CITY OF AUSTIN  
APPLICATION TO BOARD OF ADJUSTMENT  
GENERAL VARIANCE/PARKING VARIANCE

CITY OF AUSTIN – PLANNING AND DEVELOPMENT REVIEW DEPARTMENT  
SITE PLAN APPLICATION – MASTER COMMENT REPORT

CASE NUMBER: SP-2013-0439D  
REVISION #: 00  
CASE MANAGER: Rosemary Avila  
UPDATE: U1  
PHONE #: 512-974-2784

PROJECT NAME: 2921 Westlake Cove  
LOCATION: 2921 WESTLAKE CV Bldg BD

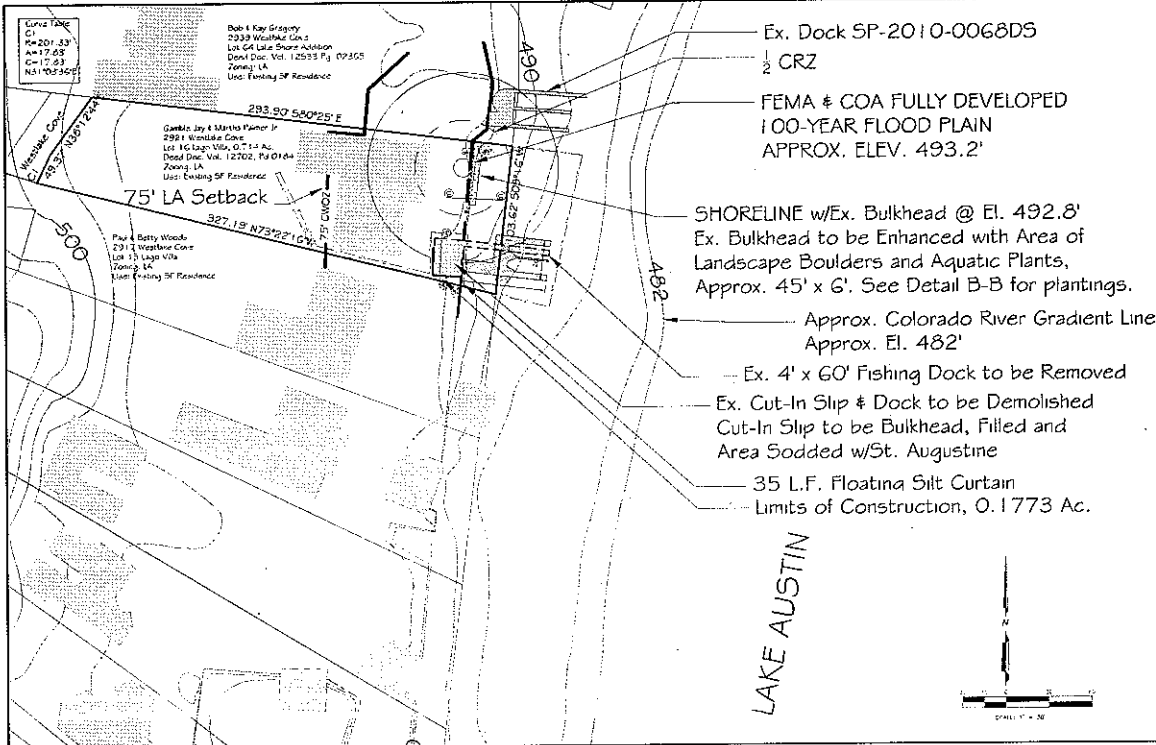
EV 9 Show on the plan specific location, species, container size and spacing of new shrubs, ground covers and grasses required for the restoration of the fill area or equivalent square footage along the shoreline. This comment is related to meeting the ECM 1.7 Floodplain Modification Criteria.

EV 10 Show all permanent improvements within the shoreline setback.

SP 12. It appears that the proposed boat dock extends approximately 60 feet from the shoreline, exceeding the allowed maximum of 30 feet [Section 25-2-1176(B)(2)]. Either reduce this extension into the lake, or request approval from the Planning Commission.

SP 13. The proposed width of the boat dock exceeds twenty percent (20%) of the length of the shoreline and must get approval from the Planning Commission.

**UPDATE 1:** Per 25-8-261(G) Floodplain modifications are prohibited in the critical water quality zone unless:

**UPDATE 1:** Not addressed. In addition, please demonstrate that all permanent improvements are permitted.

**U1: Comment to remain until PC approval. Please clarify why the proposed dock is this long.**

**U1: Comment to remain until PC approval. Please clarify why the proposed dock is exceeding the 20% shoreline width.**

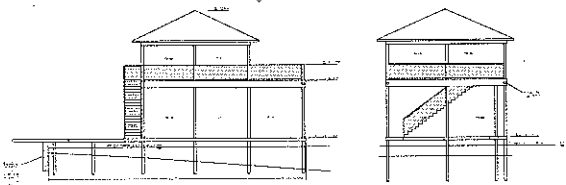
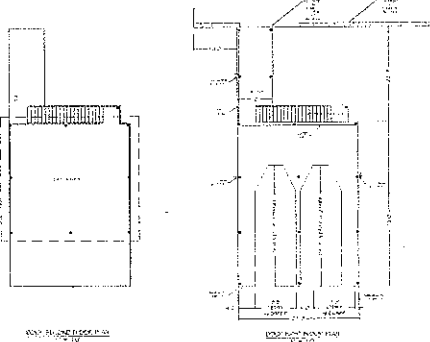
SP 17. **Please add dock dimensions (height) on page 3.**
